Notice of Allowability	Application No.	Applicant(s)
	10/046,444	TRIPATHI ET AL.
	Examiner	Art Unit
	Cicely Ware	2634

EXAMINER'S AMENDMENT

FIG. 1

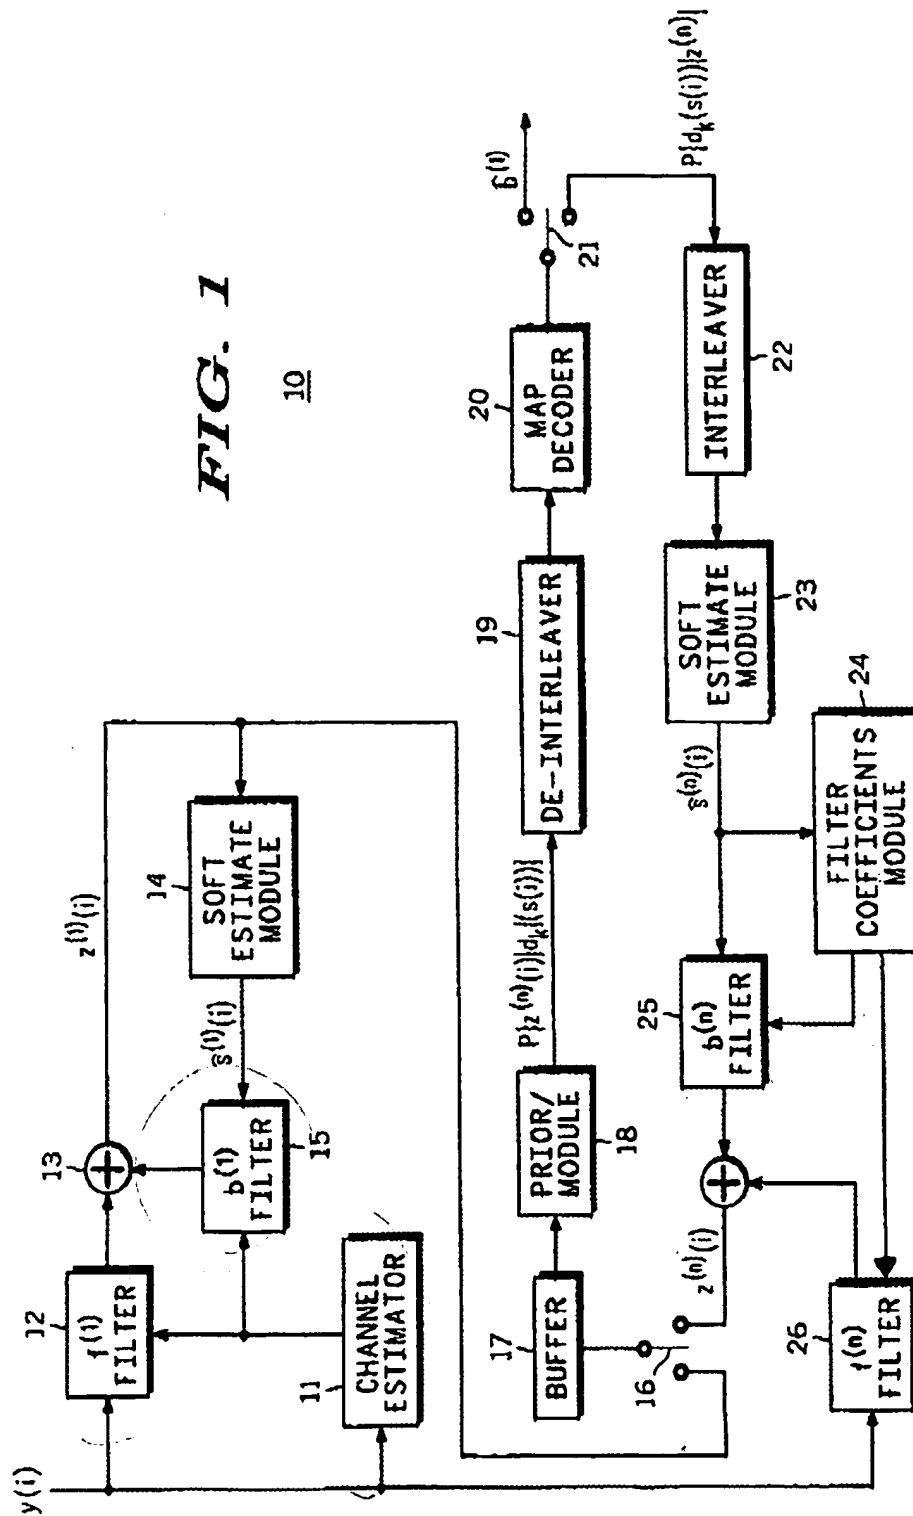
3.   Insert arrow in Fig. 1 element 25 (See Replacement Sheet).
